ADDISON EXPRESS
HANGER ADDITION
4500 Claire Chennault
Addison, Texas

PLAN VIEW
APRON PLAN & DETAILS

G-3

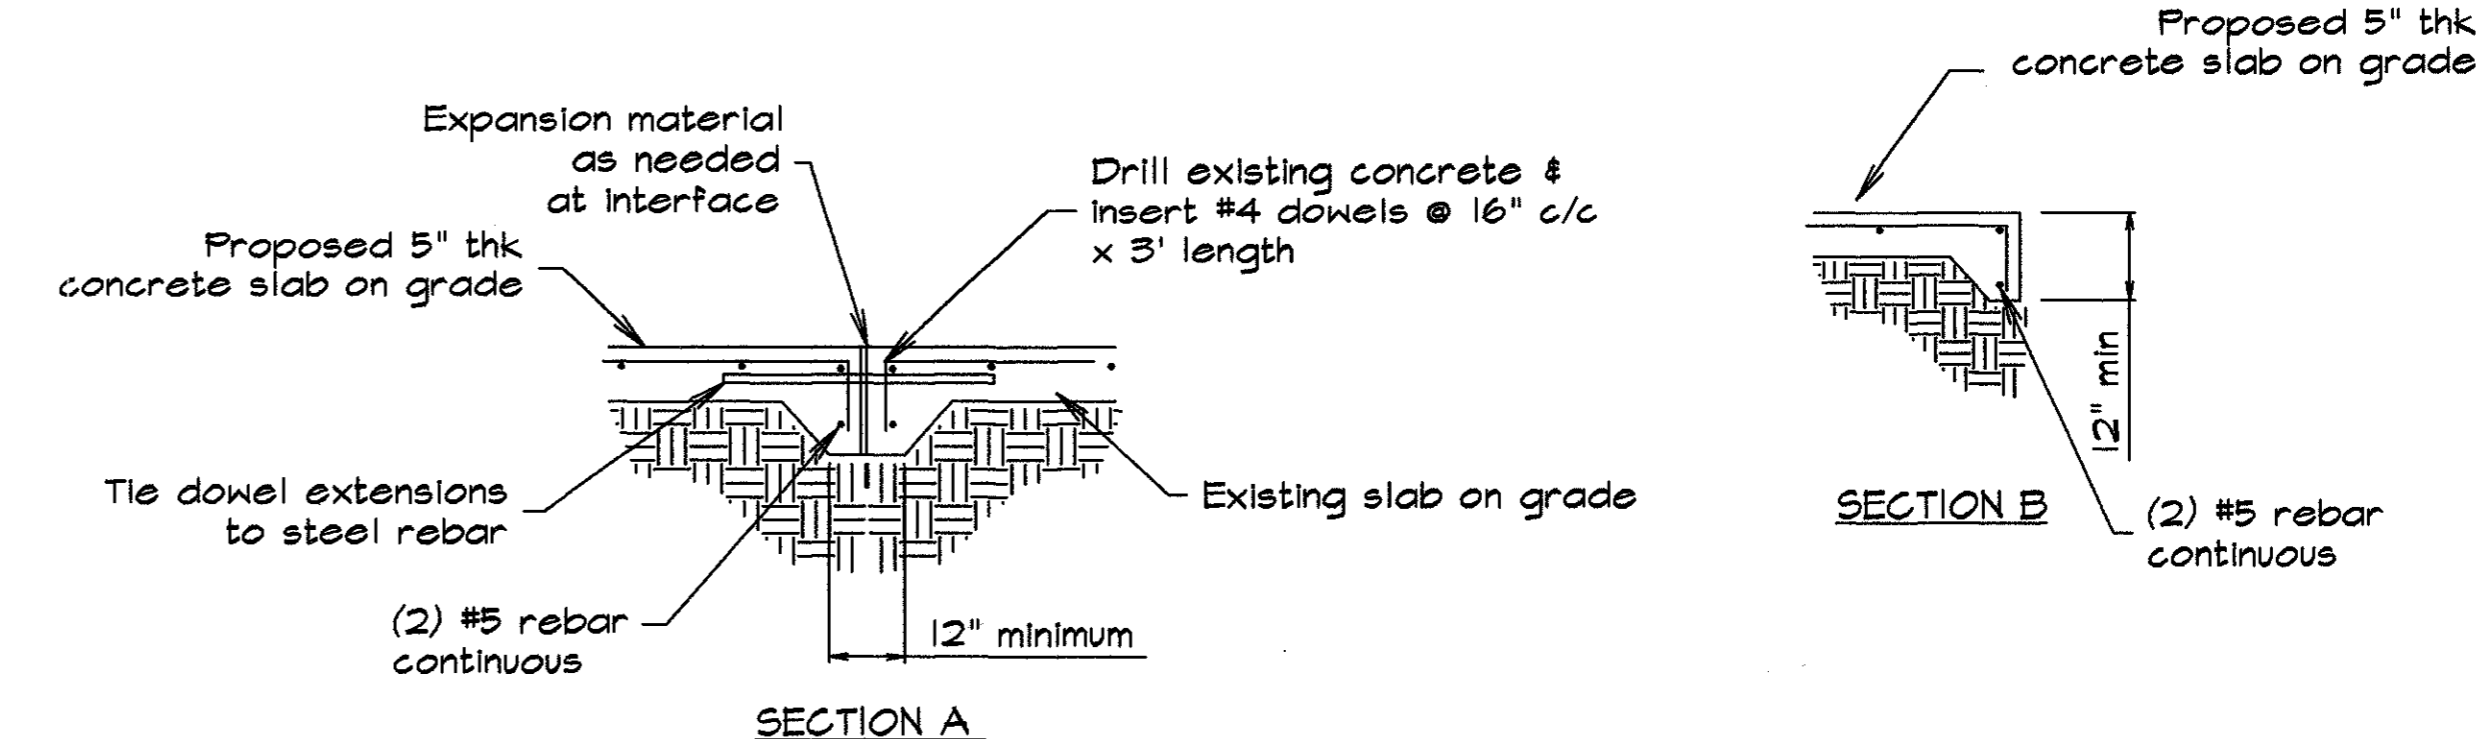
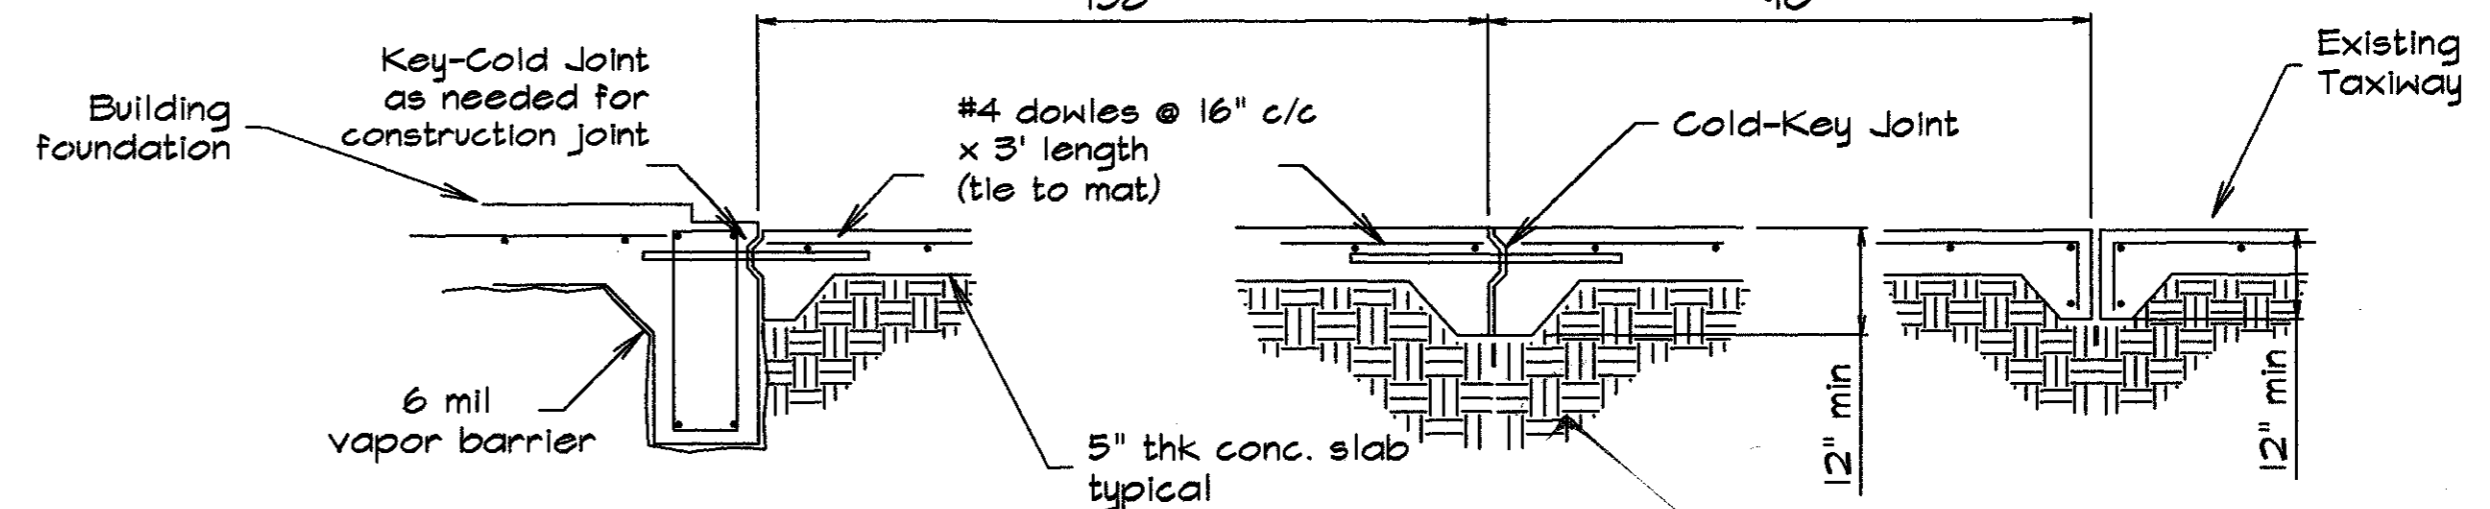
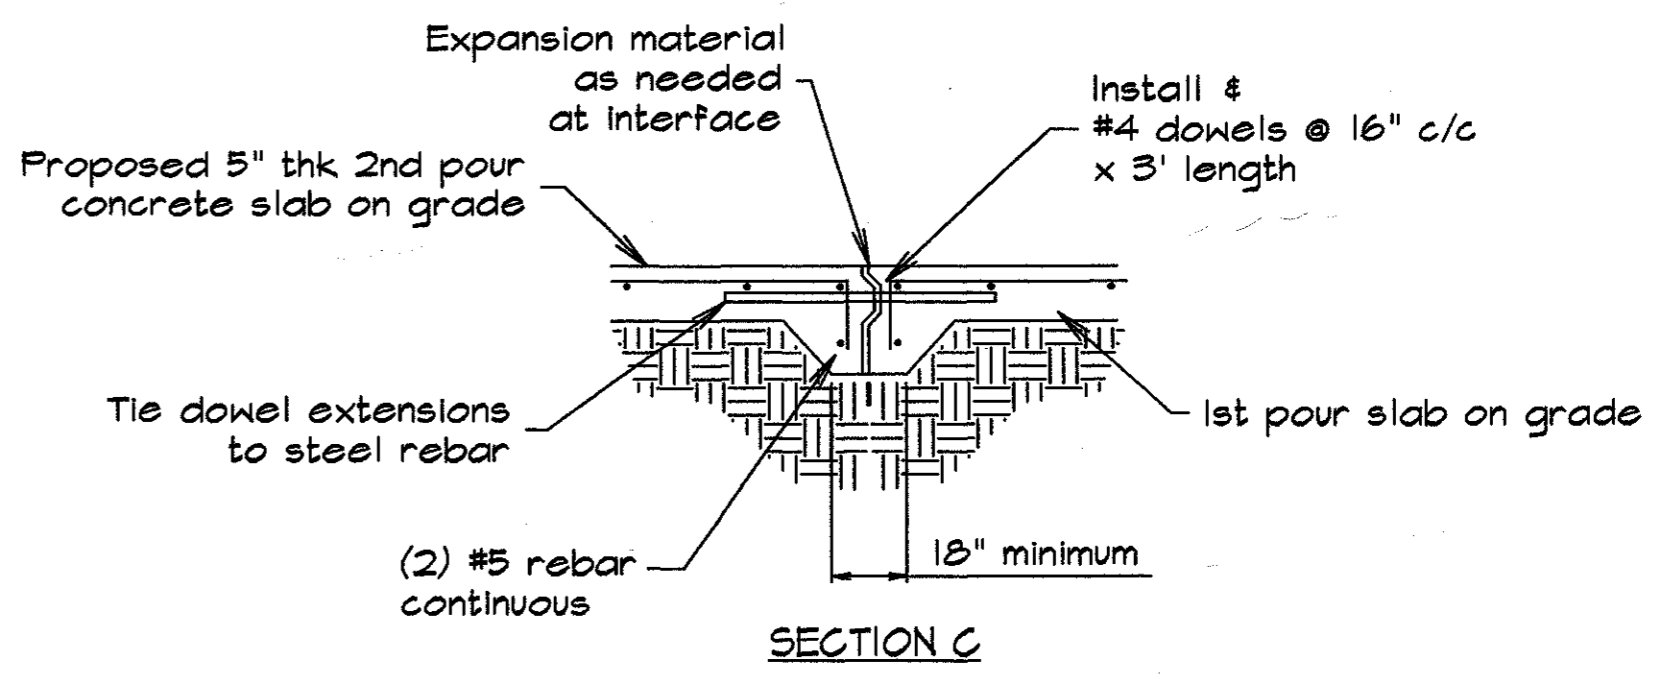
PERMIT FOR RAMP ONLY. OWNER
MAY PROCEED AT OWN RISK NO
FUTURE PERMITS WILL BE APPROVED
UNLESS ALL LAWS & ORDINANCES
OF THE TOWN OF ADDISON ARE
COMPLIED WITH.
